Access Compliance Report

Public Rights-of-Way

Intersection ID: 3258	Main Street: GLEN_HOPE_LN	Cross Street: SHADOW_PINE_DR	Location: E
ADA ID: 739BC6EF07D3	Ramp Type: Perp	Initial Pass/Fail: Fail	Overall Compliance: No
		Severity Score: 10

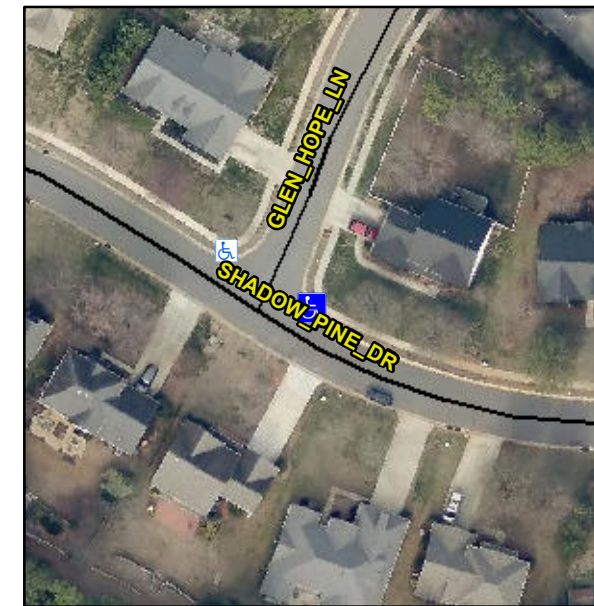
Not Found, R304.5.1, R304.5.3

Compliance	Description	Data	Compliance	Description	Data
N/A	Ramp Length (in)	45.0	Yes	Ramp Slope (%)	6.0
No	Ramp Width (in)	45.5	No	Ramp XSlope (%)	3.6
N/A	Flare Type LT	N/A	N/A	Flare Type RT	N/A
N/A	Flare Slope LT (%)	N/A	N/A	Flare Slope RT (%)	N/A
N/A	Flare Traversable LT?	N/A	N/A	Flare Traversable RT?	N/A
N/A	Landing Length (in)	N/A	N/A	DWS Provided?	N/A
N/A	Landing Width (in)	N/A	N/A	DWS Contrast?	N/A
N/A	Landing Slope (%)	N/A	N/A	DWS Length (in)	N/A
N/A	Landing X Slope (%)	N/A	N/A	DWS Full Width?	N/A
N/A	Landing Curb? (Y/N)	N/A	N/A	DWS Offset (in)	N/A
N/A	Shared Landing?	N/A			
N/A	Gutter Ponding?	N/A	N/A	Gutter Slope (%)	N/A
N/A	Gutter Lip Ht (in)	N/A	N/A	Gutter X Slope (%)	N/A
N/A	Painted X Walk1?	No	N/A	Painted X Walk2?	N/A
	X Walk 1 Direction	To NW		X Walk 2 Direction	N/A
N/A	X Walk 1 Width (in)	N/A	N/A	X Walk 2 Width (in)	N/A
	X Walk 1 Slope (%)	0.8		X Walk 2 Slope (%)	N/A
	X Walk 1 X Slope (%)	5.8		X Walk 2 X Slope (%)	N/A

Remove & Replace Entire Ramp.
